RE: **EM-CING-097-181206** – New Cingular Wireless, PCS, LLC (AT&T) notice of intent to modify an existing telecommunications facility located at 20 Barnabas Road, Newtown, Connecticut.

**SITE NUMBER: CT5178**

**PROJECT: LTE 2C/3C 2019 UPGRADE**

Staff has reviewed this exempt modification request for completeness and has identified a deficiency in the request. The construction drawing Sheets A1, A2 and A3 prepared by Hudson Design Group, last revised on November 27, 2018, include a structural note stating "all antennas and RRH's to be mounted in accordance with structural analysis provided by Malouf Engineering Intl. Inc. and final RF data sheet". The Structural Analysis provided with the request is prepared by All-Points Technology Corporation and dated November 5, 2018. This is inconsistent with the above referenced Construction Drawings.

COMPOUND & EQUIPMENT PLAN  
(LTE 2C/3C)

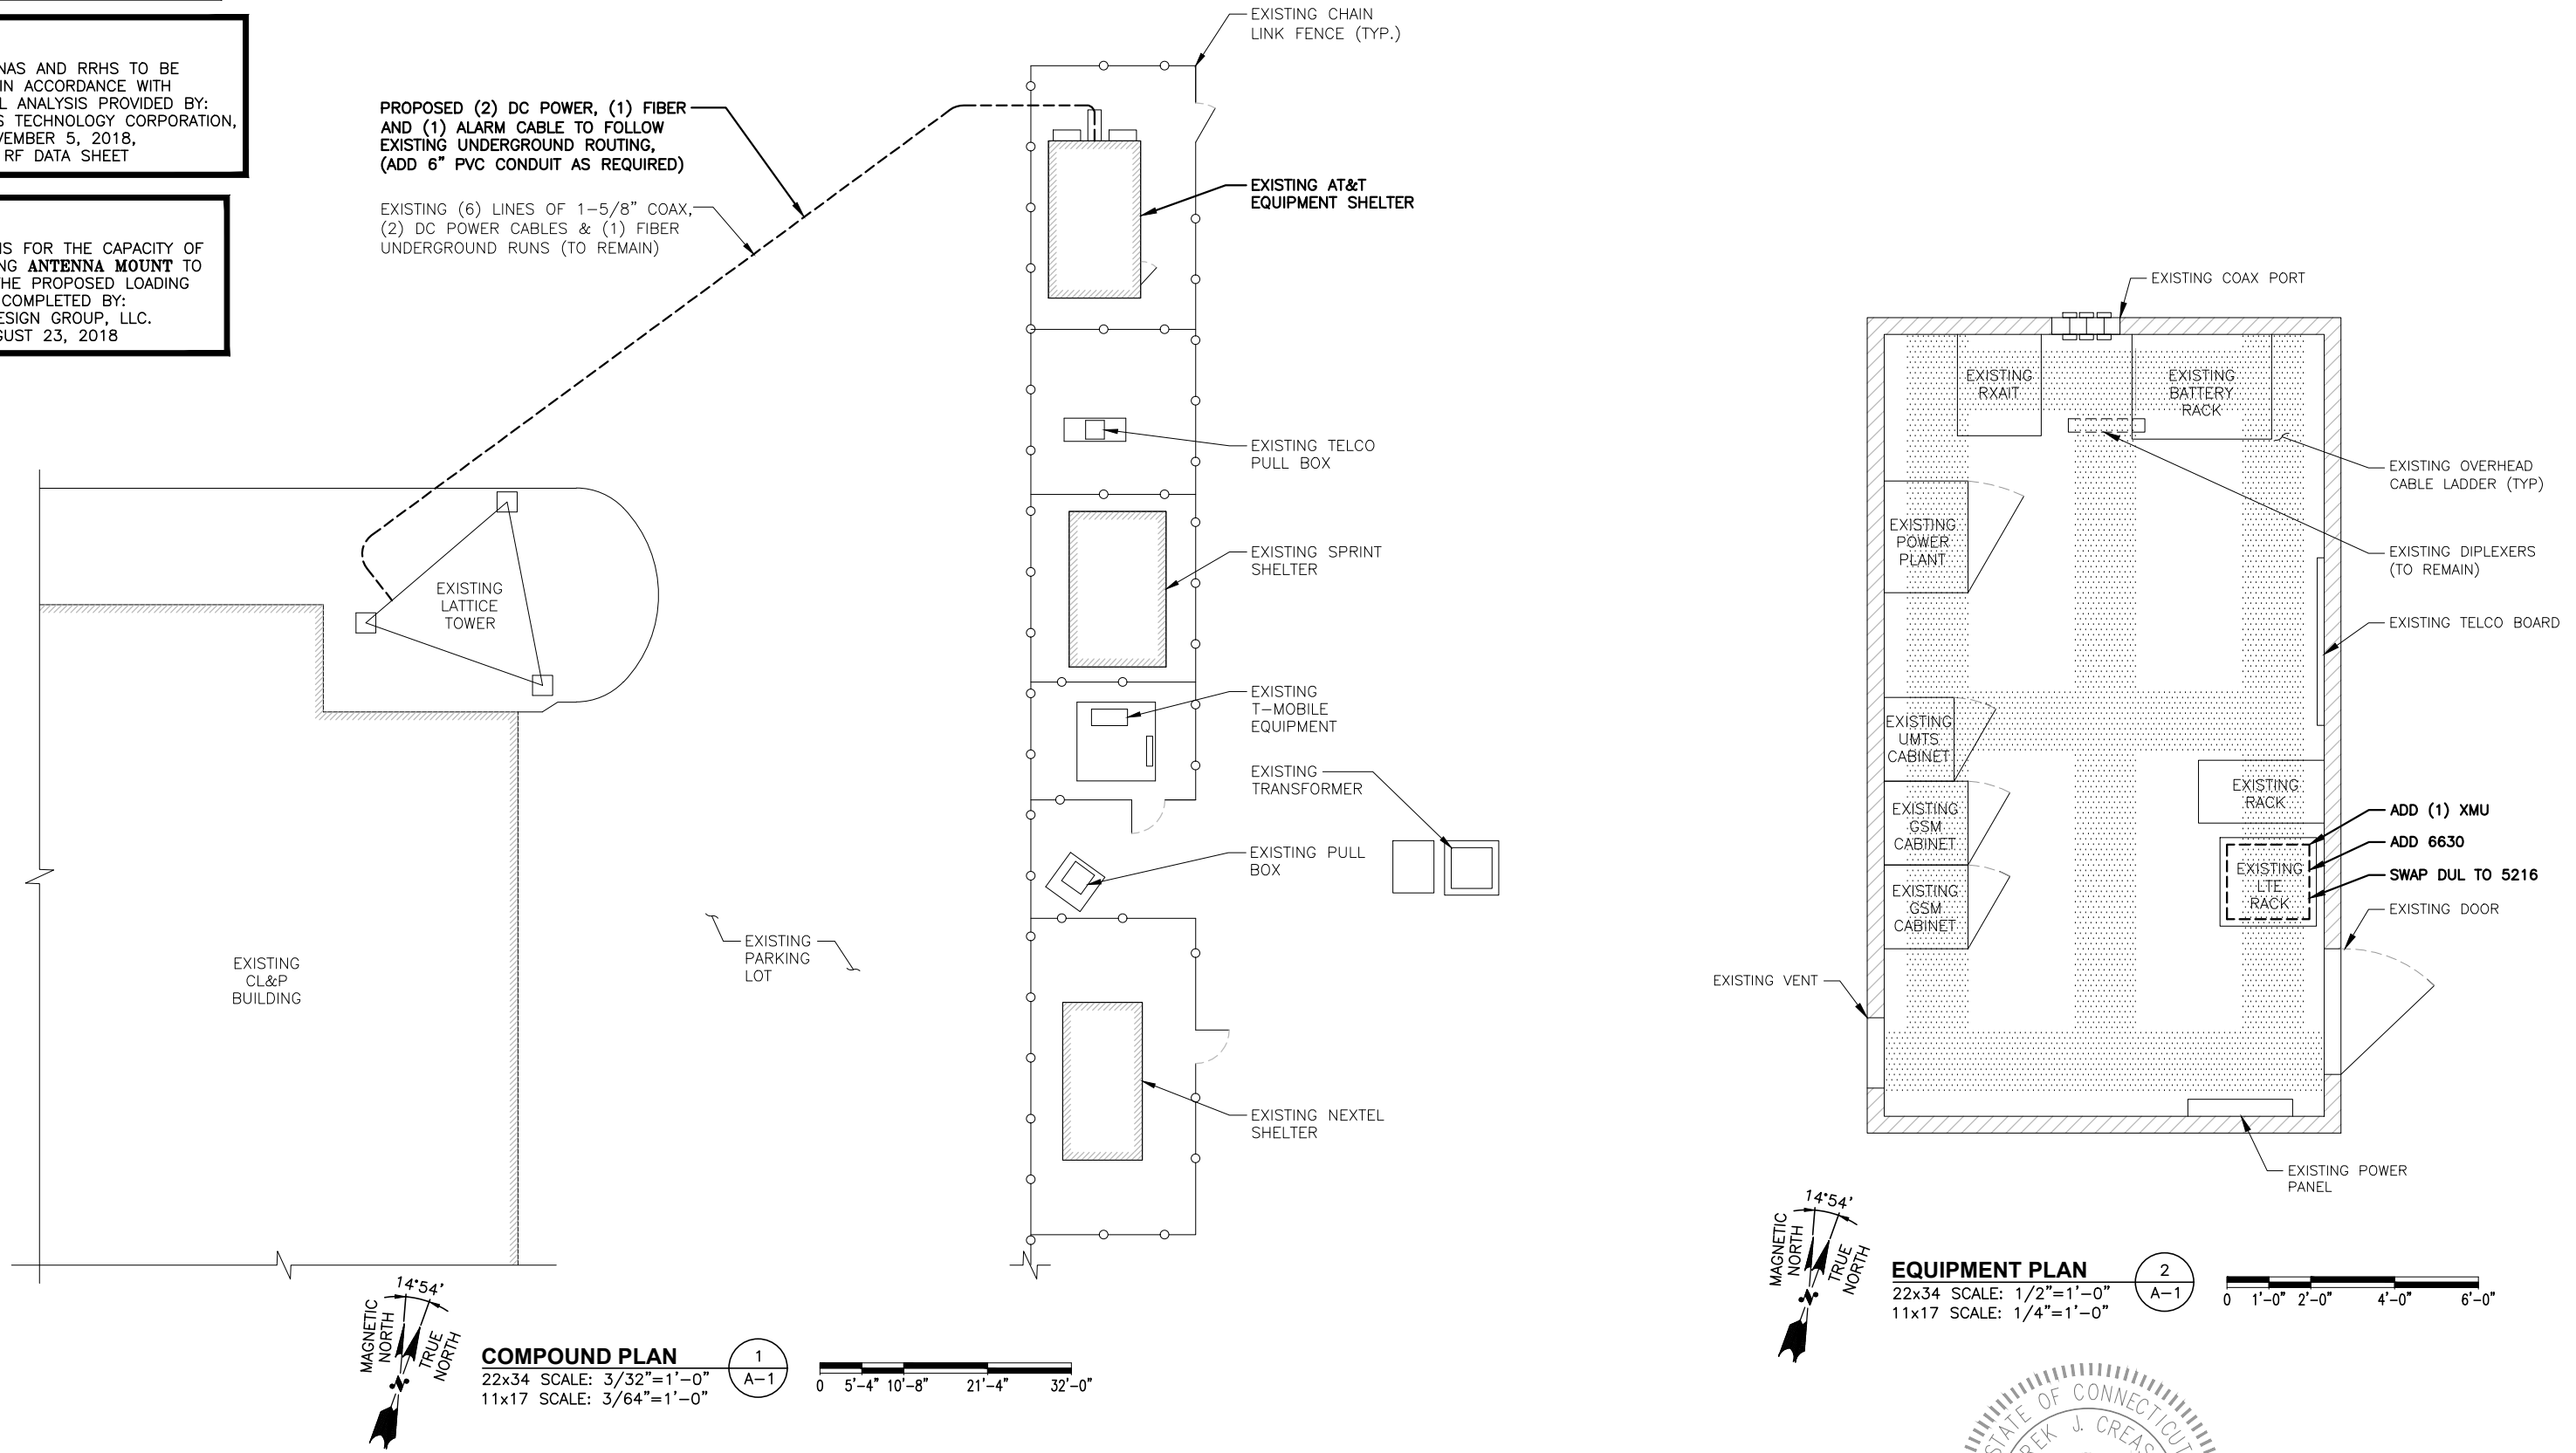
Therefore, the exempt modification request is incomplete at this time. The Council recommends that Centerline Communications provide clarification on the above referenced structural note and construction drawings that are consistent with the Structural Analysis Report and the Mount Analysis provided with the request on or before January 14, 2019. If additional time is needed to gather the requested information, please submit a written request for an extension of time prior to January 14, 2019.

In response to the CSC memo dated 12/10/18, attached please find the revised Construction Drawings.

**NOTE:**  
ALL ANTENNAS AND RRHS TO BE INSTALLED IN ACCORDANCE WITH STRUCTURAL ANALYSIS PROVIDED BY: ALL-POINTS TECHNOLOGY CORPORATION, DATED: NOVEMBER 5, 2018, AND FINAL RF DATA SHEET
